SERVICE & PARTS TECHNICAL INFORMATION

Triumph

CYLINDER HEAD TORQUE SPECIFICATION

TR7

FIGURE I

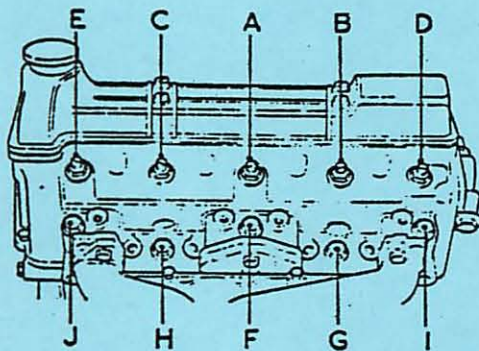
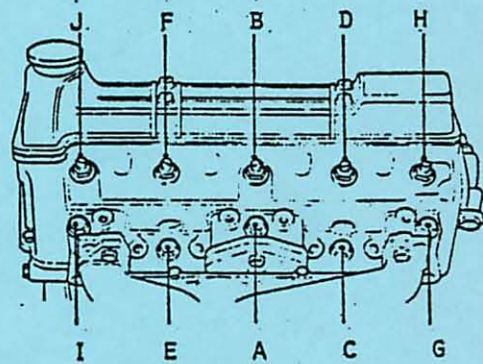
The 1978/79 scheduled maintenance and specification cards quote the cylinder head torque for the TR7 at 45-55 lbs ft. This torque specification only applies to vehicles prior to engine no. CV10330. Vehicles subsequent to engine CV10330 incorporate new cylinder head bolts, studs, nuts and washers requiring a new tightening sequence and a revised torque figure of 45-50 lbs ft.

TORQUE 45-55 lbs/ft.

Previous Head Tightening
Sequence

TORQUE 45-50 lbs/ft.

New Head Tightening
Sequence
